# UNITED STATES PATENT AND TRADEMARK OFFICE

10/728,117

# Office Action Summary

## **DETAILED ACTION**

**FIG. 4**

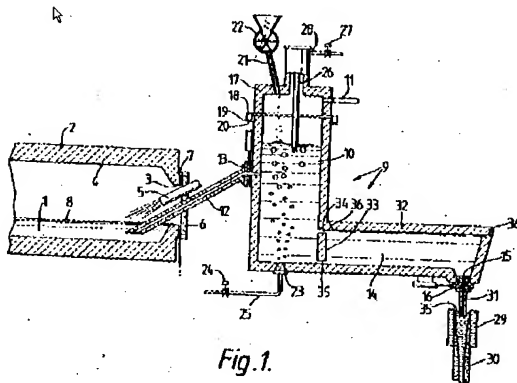
Claims 1 to 7 are rejected under 35 U.S.C. 103(a) as being unpatentable over Nashiwa et al (US 4,043, 798). Nashiwa et al discloses a process for producing steel using a projectile for introducing calcium into molten steel as shown in FIG.4

The projectile has a diameter of 5 to 100mm, preferably 25 to 50 mm which overlaps the claimed feeding pieces with a size 2 to 50 mm (col. 4, lines 23 to col.5, line 54) in view of which the crux of the process as claimed in Claim 1 is regarded as obvious. The

apparatus limitation of Claims 9, 10 and 11 are regarded as obvious since these features are conventional.
